Docket Item # 1
BAR CASE # 2016-0040

BAR Meeting
March 16, 2016

ISSUE: Certificate of Appropriateness - Alterations

LOCATION: 700 South Washington Street

Figure 2: Current Application/Proposal

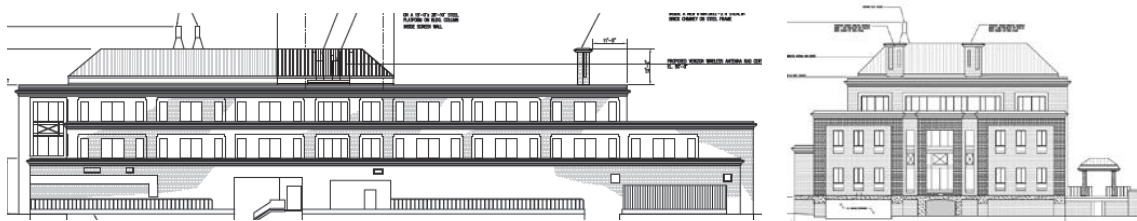
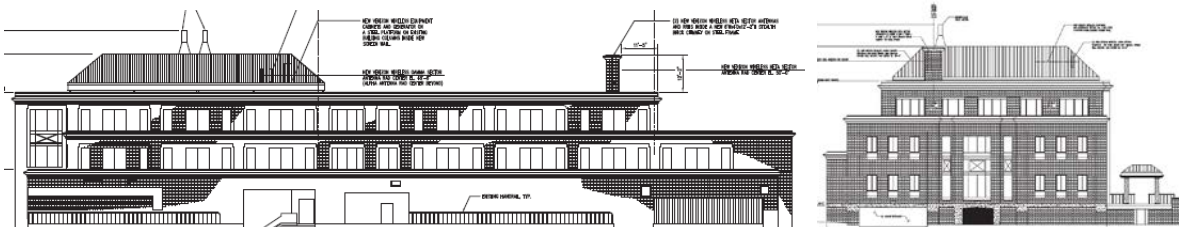
The applicant’s design team is commended for their continued study and examination of alternative design schemes for the proposed telecommunication equipment. On December 17, 2014, the applicant previously received a Certificate of Appropriateness to expand the existing penthouse screen and to install two “chimneys” on the east side of the roof to conceal wireless antennas. During this meeting, although the BAR approved the Certificate of Appropriateness, they expressed concerns with the scale of the applicant’s design and its impact to the George Washington Memorial Parkway. After this public hearing, the applicant continued to work with their engineers and BAR staff on alternative design schemes. The current submittal is a new application, which is the result of this hard work.

The current application proposes to replace portions of the existing standing seam metal penthouse screen on the roof of the existing building with Stealthcore, molded and painted to match the existing standing seam screen. Stealthcore is a PVC composite material manufactured to maximize cellular frequency output. These Stealthcore panels will contain 1” high “seams” and be joined with lap (scarf) joint. The telecommunications mechanical equipment and cellular antennas will be housed behind these new screens.

The application also proposes to install a single “chimney” to house two, cellular antennas on the east side of the roof, offset 6’8” from the south building wall and 11’5” from the east building wall. The chimney will also be fabricated from the Stealthcore material. The base will contain a brick base and the top will replicate a cast concrete or stone chimney cap.

Staff finds that the proposed rooftop screening is substantially smaller than the previous application, is compatible with the existing architectural materials and requires minimal changes to the building. The proposed “chimney” will be mounted on the structure without any negative impacts to the existing building fabric so that it can easily be removed in the future if/when the cellular technology becomes obsolete. Staff believes that the design, as submitted, is a positive solution to a very challenging problem, will not negatively impact the George Washington Memorial Parkway, and is consistent with the BAR’s *Design Guidelines*. Staff recommends approval of the application, as submitted.

Staff recommends approval the Certificate of Appropriateness, as submitted.

SOUTH BUILDING ELEVATION

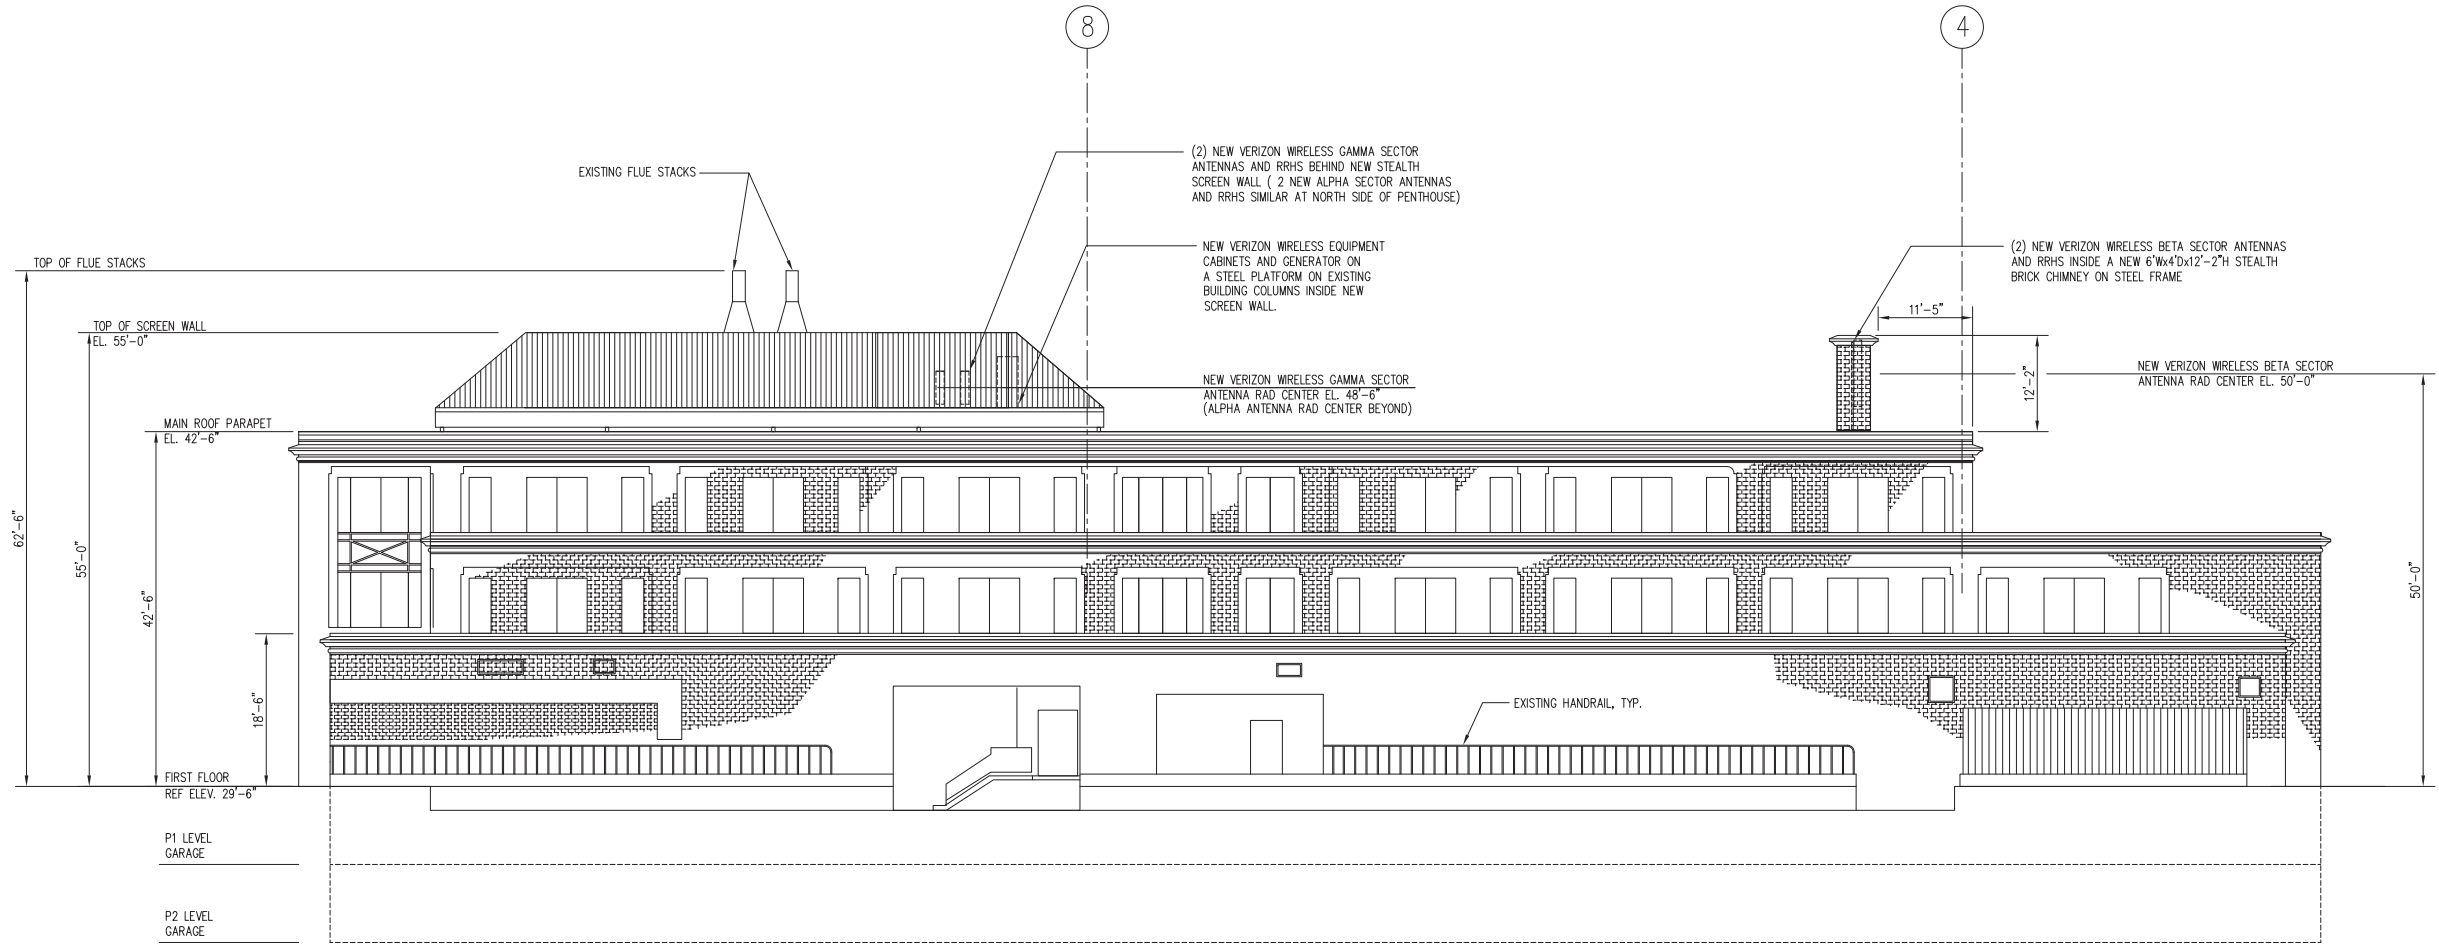
R-1 That the new screening should be matched in color, texture, profile, sheen, etc. to the existing.
